orbit_demo review notes: issues, trade-offs, questions, discrepancy register

Package section 09_review_notes of orbit_demo_design_review, written 2026-10-06. Links are relative to this file. Paths in backticks without a link (reports/..., build/..., site/..., viz/..., docs/research/..., ORFS image paths) are repository, build or tool-image paths in /home/user/chip that are not copied into the package, unless a package copy is linked next to them or listed in [README.md](#) under How the package was built. "repo" = /home/user/chip.

Item	Revision / identifier	Note
Design	orbit_demo (ORBIT-AI 4-lane INT8 digital demonstrator)	top module orbit_demo, LANES=4
RTL	rtl/orbit_demo.v, orbit_mac_lane.v, orbit_thermal_tmr.v, orbit_keep_reg.v at git commit 26d71a8 (work dated 2026-09-29 18:54 UTC; see the note on commit dates below); unchanged through the package commit	sha256 a3fffb22... / efef3d33... / bba77a5a... / ea05bdc1... (full hashes in MANIFEST.sha256 at the package root)
Specification	docs/SPEC.md at 26d71a8 (never revised)	sha256 aef5d9fb...
Concept brief	docs/orbit-ai-design-brief.pdf, "ORBIT-AI v0.1, 29 September 2026" (never revised; describes an earlier project state, see disc

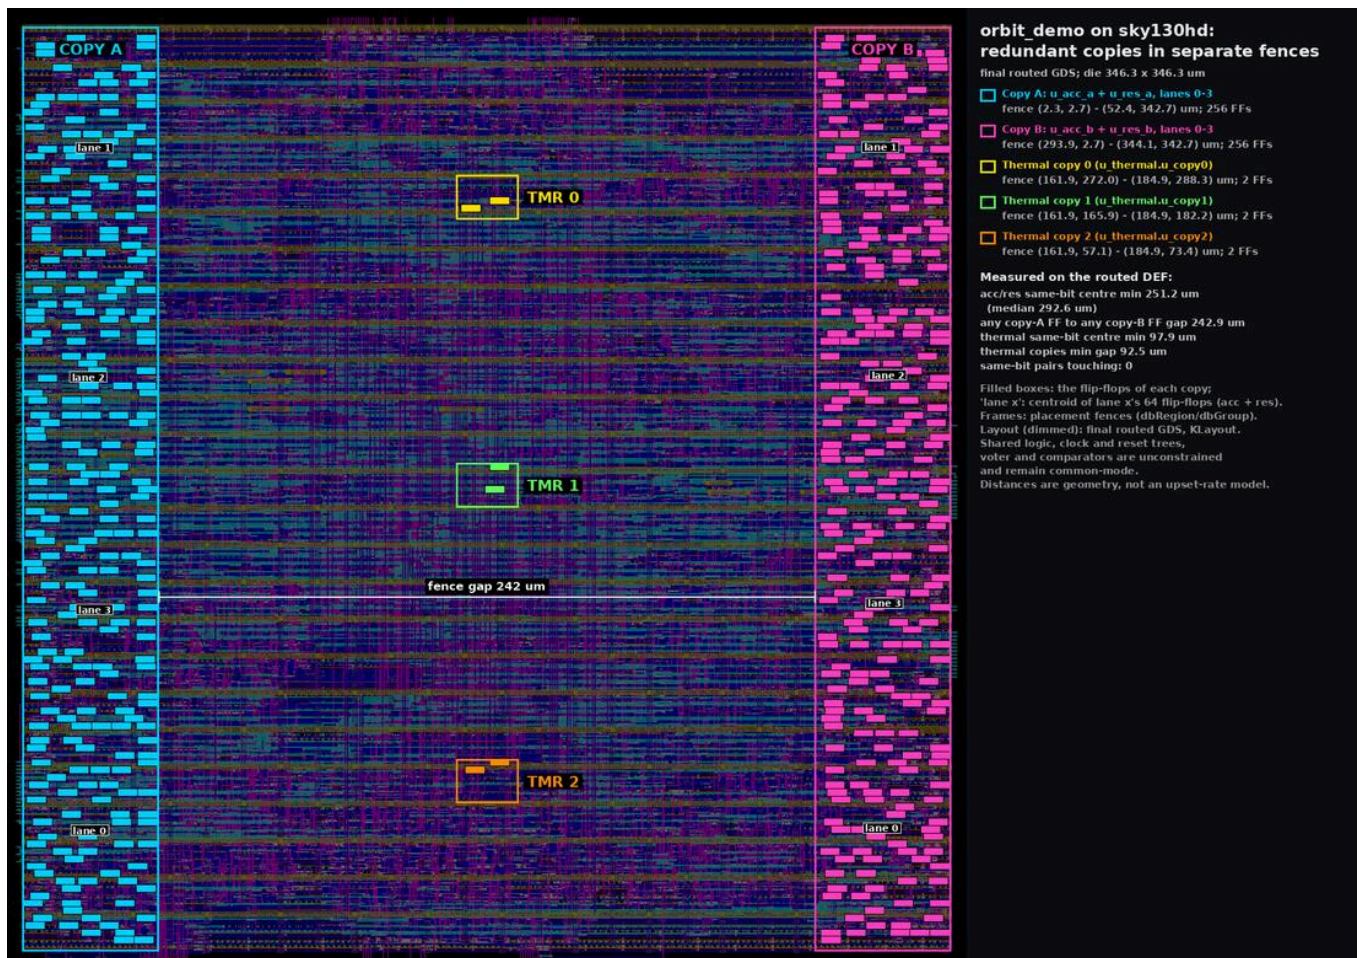
ID	Sev.	Issue and evidence	Source (package; repo/build if different)	Conditions	Status
K-01	High	Setup fails at ss_100C_1v60 on the reviewed layout. Setup WNS –6.131 ns, TNS –2463.532 ns, 516 violating endpoints: all 512 bits of g_lane[0..3].u_lane.u_{acc_a,acc_b,res_a,res_b}/q[*], plus out_valid_q, fault_q and outputs in_ready (–4.142 ns) and out_valid (–3.838 ns). Worst path in_a[12] → g_lane[1].u_lane.u_acc_a/q[31]\$_SDFFE_PN0P_.reg2reg also fails (–4.420 ns at g_lane[0].u_lane.u_res_b/q[30]), so the failure is not only the I/O budget. Min period 13.33 ns (75.01 MHz) with I/O delay held at 1.44 ns. At SS also 37 max-slew and 12 max-capacitance violating pins. Hold is met at all corners (smallest: FF 0.281 ns). TT: WNS +0.031 ns; FF: +2.276 ns. The only committed corner report is for the baseline (–6.016 ns at 7.0 ns).	sta_corners_sep.txt , sta_corners_sep_supplement.txt , sta_ss_100C_1v60.log , sta_extra_ss_100C_1v60.log (endpoint list, 516 VIOLATED); baseline sta_corners_baseline_7p0ns.txt	OpenSTA in OpenROAD "unknown", image sha256:2e5bf6fe865e; pd/sta_corner.s.tcl unmodified; build/pd_sep/results/sky130hd/orbit_demo/sep/6_final.{odb,sdc,spef}; 7.2 ns, I/O delay 1.44 ns, propagated clock; nominal OpenRCX SPEF at every corner; no derate/OCV/uncertainty; design optimised by ORFS at TT only	REPRODUCED 2026-10-06

ID	Sev.	Issue and evidence	Source (package; repo/build if different)	Conditions	Status
K-04	High	DRC deck scope. KLayout DRC reports 0 markers, but the ORFS deck sky130hd.lydrc sets FEOL = false, BEOL = true, OFFGRID = true (image file lines 46-48). The log contains only "DRC section", "BEOL section" and "OFFGRID-ANGLES section" (6_drc.log:257-258, 1222). The 145 lyldb categories are li/ct/m1-m5/via-via4/nsm/pad and off-grid/angle; no well, diff/tap, poly, licon or implant rules, no density, no latch-up (LU.2/LU.3) rules. No metal fill: 6_1_fill.log:10 only copies 5_route.odb. TritonRoute "0 violations" skipped LEF58_ENCLOSURE for mcon, via, via2, via3, via4 (5_2_route.log:12-21). KLayout LVS ("Congratulations! Netlists match.", 6_lvs.log:652) compares the GDS with a CDL written from the same 6_final.odb (6_cdl.log), so it checks the stream-out, not an independent reference. Sign-off DRC/LVS: MISSING.	6_drc.log, 6_drc.lyldb, 6_drc_count.rpt, 6_1_fill.log, 5_2_route.log, 6_lvs.log, 6_cdl.log; deck /OpenROAD-flow-scripts/flow/platforms/sky130hd/drc/sky130hd.lydrc (image)	KLayout 0.30.12; deck read from image 2e5bf6fe865e on 2026-10-06	VERIFIED

K-05	High	No pad ring, IO cells, ESD, package or seal ring. finish_design_instance_count_padcells 0; power group "Pad" 0; all 18175 DEF components are sky130_fd_sc_hd cells. The 215 signal pins are minimum-size met2/met3 boundary pins placed by place_pins without a pinout constraint (W 102, S 42, N 42, E 29); VDD/VSS are met5 straps. 215 signal bits would need a large pad-limited die or IO multiplexing. Package/pad ring/ESD: MISSING. The package views in viz/ and site/ are labelled mockups (N/A as evidence).	6_report.json line 60; power_default_activity.txt; pinout.csv; 6_final.def.gz	sep run; pin edges counted from pinout.csv 2026-10-06	VERIFIED
K-06	Medium	No EM sign-off; power and IR drop rest on default activity. Power 52.1092 mW (internal 26.3633, switching 25.7459 mW, leakage 0.0279 uW) with OpenSTA default switching activity, no VCD/SAIF; the numeric default is not reported. Static PSM IR drop from that power: VDD worst 0.4539 mV (0.03 %), VSS worst 0.6275 mV. No dynamic IR, no package/bump model, no decap cells (decap budget MISSING). ORFS calls analyze_power_grid without -enable_em; no flow log has EM output. A package re-run with -enable_em gives grid currents (max VDD 4.05e-04 A, VSS 4.33e-04 A). The tech LEF read by the run has DC/AC current-density limits per layer and via (e.g. met1 DCCURRENTDENSITY AVERAGE 2.8, ACCURRENTDENSITY RMS 6.1 mA/um at Tj = 90 C; read from the local image copy, ASSUMPTION: same file as the run), but no step compared the currents with them. EM sign-off: MISSING.	power_default_activity.txt; 6_report.log 27-50; rerun ir.log 17-21, 36-40, ir.tcl; 1_synth.log 7; final_outputs.tcl 43, 52 and platforms/sky130hd/lef/sky130_fd_sc_hd.tcl 91-283 (image)	TT 25C 1.80 V, 7.2 ns, OpenRCX SPEF; PSM corner "default", supply 1.80 V from platform PWR_NETS_VOLTAGES	VERIFIED

13. Are the 109 non-member cells overlapping the fences acceptable, or should whole domains (voter, enables, comparators) be fenced (research note P1; K-13)?
